# PLANNING AND ZONING COMMISSION MEETING (AMENDED)

City Council Chambers, 33 East Broadway Avenue Meridian, Idaho  
Thursday, January 20, 2022 at 6:00 PM

# STAFF REPORT

B. Revised Site Plan with Markups

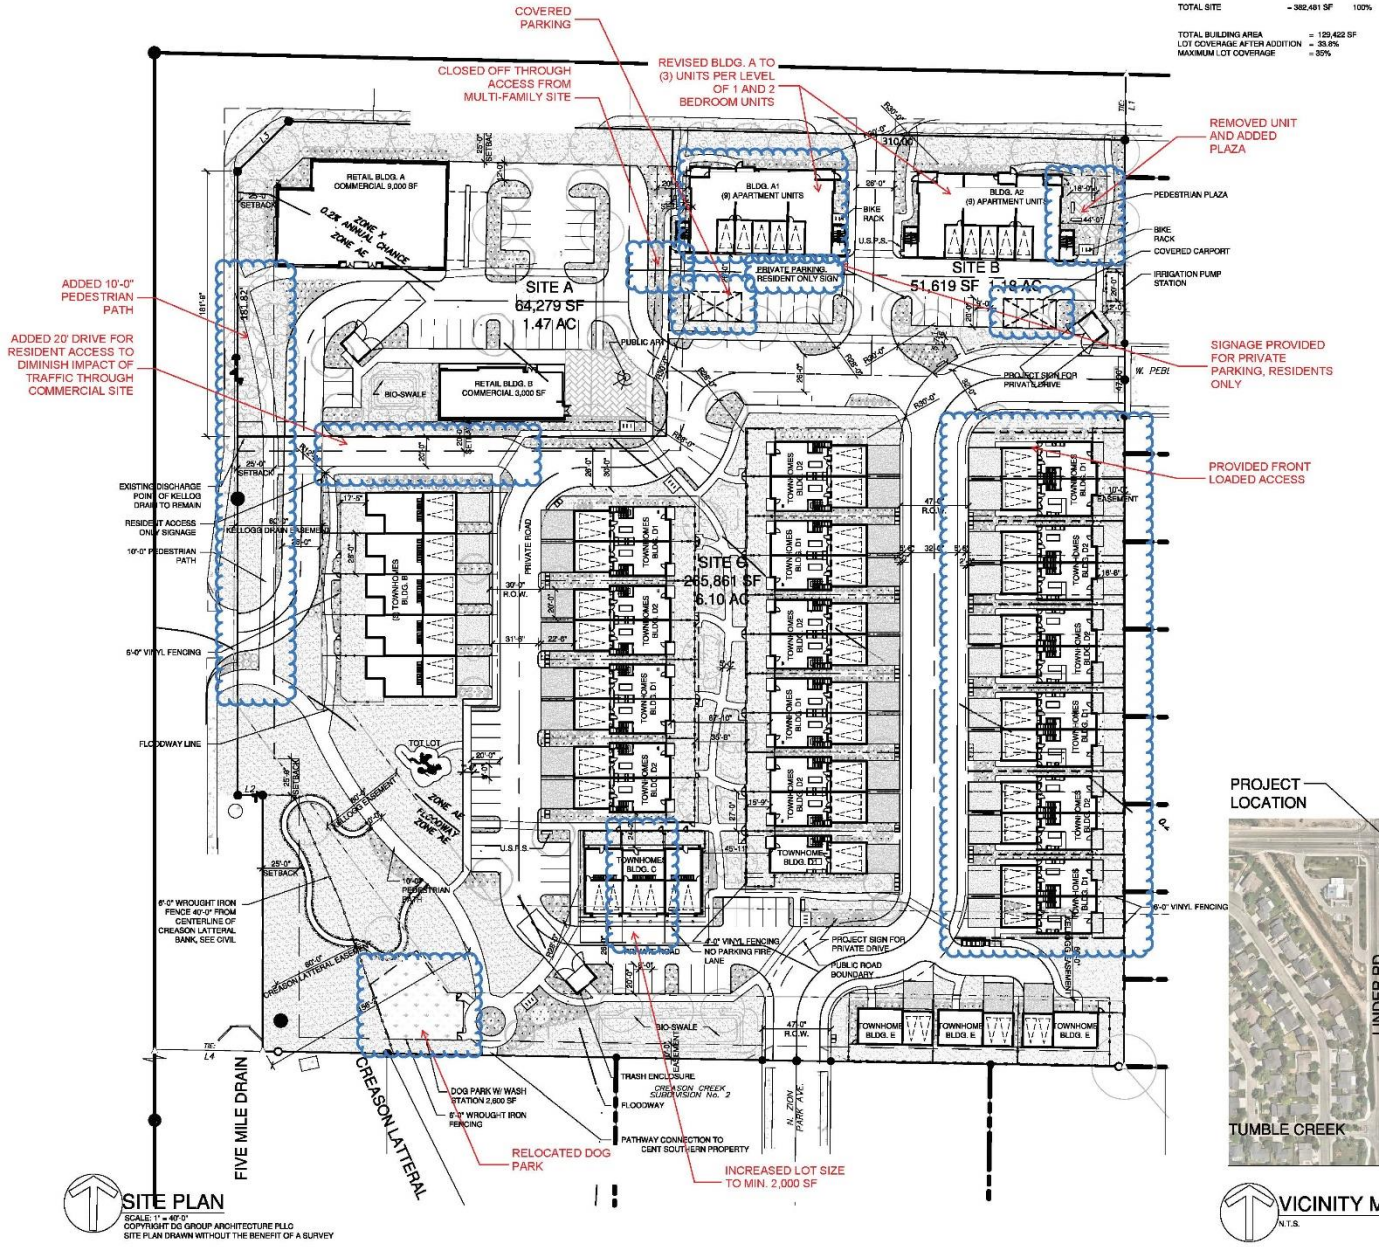
The parameters of the Commission motion to continue and the revised plans have resulted in Staff modifying certain conditions, striking others, and adding an additional DA Provision. Staff recommends the following changes be made to the staff report by the Planning and Zoning Commission, noted with strikeout and underline changes below:

- Modify A.1f. – No more than ~~16~~18 multi-family units are approved with the Lennon Pointe Community development—~~the first two units closest to the east property boundary and Creason Creek Subdivision are limited to two-story units in height.~~
